Primary Facade (Applicant)

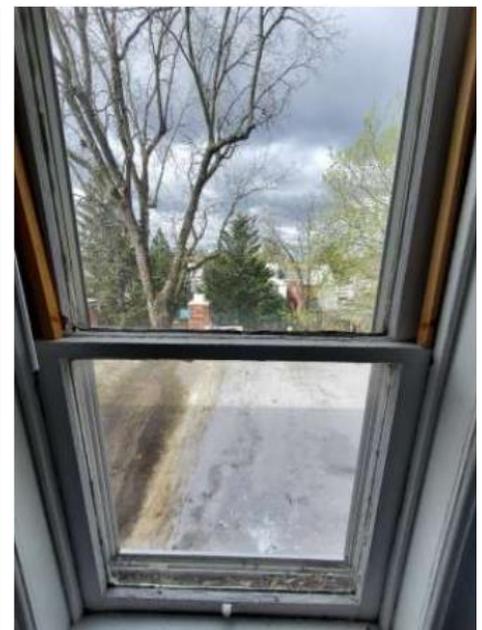
Repair and reuse of wood windows, or in-kind replacement, are the most appropriate treatments. Aluminum-clad wood windows are an acceptable alternate material per Guideline 3.5.9. The proposed replacements are 1/1 double-hung, which match the existing configuration and operation, and will be fit to the existing opening. These factors are consistent with the Guidelines.

HARB member Glenn Lichtenwalner made a motion to approve the application presented on 05/02/22 for window replacement of eight (8) lead-based paint hazard deteriorated windows with new aluminum clad windows. (Two - 2nd floor front, two - 3rd floor front, one - 2nd floor side, one - 2nd floor rear, and two - 3rd floor rear) at 430.5 N 10th Street as submitted.
